REQUEST FOR CLARIFICATIONS

RADIATION PROTECTION PLAN

Figure 2.6. Quantitative Dispersion Factors

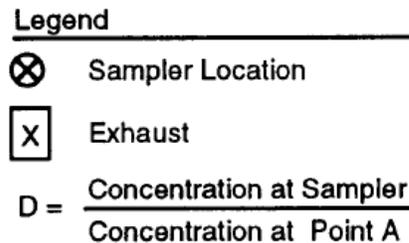
In considering an appropriate dispersion factor for particles that do not tend to become airborne, Figure 2.6 of NUREG-1400 was reviewed. This figure provides an example where quantitative dispersion factors are determined directly through air sampling. Although quantitative values cannot be determined at this time, NUREG-1400 supports use of dispersion factors less than 1.

The NRC staff reviewed Figure 2.6 of NUREG-1400 and can't corroborate the licensee's interpretation. Figure 2.6 is related to Section 2.2.2.2 of NUREG-1400 discussing quantitative airflow studies. Figure 2.6 is related to the dispersion of aerosols from the source of a release:

The "D" in Figure 2.6 is referred to as the "dispersion factor". This is not the same as the "dispersibility factor" discussed in Section 1.2.3 of NUREG-1400 for determining potential intakes.

Provide a justification for the use of a dispersibility factor (D) less than 10 that is consistent with Section 1.2.3 of NUREG-1400 for determining potential intakes.
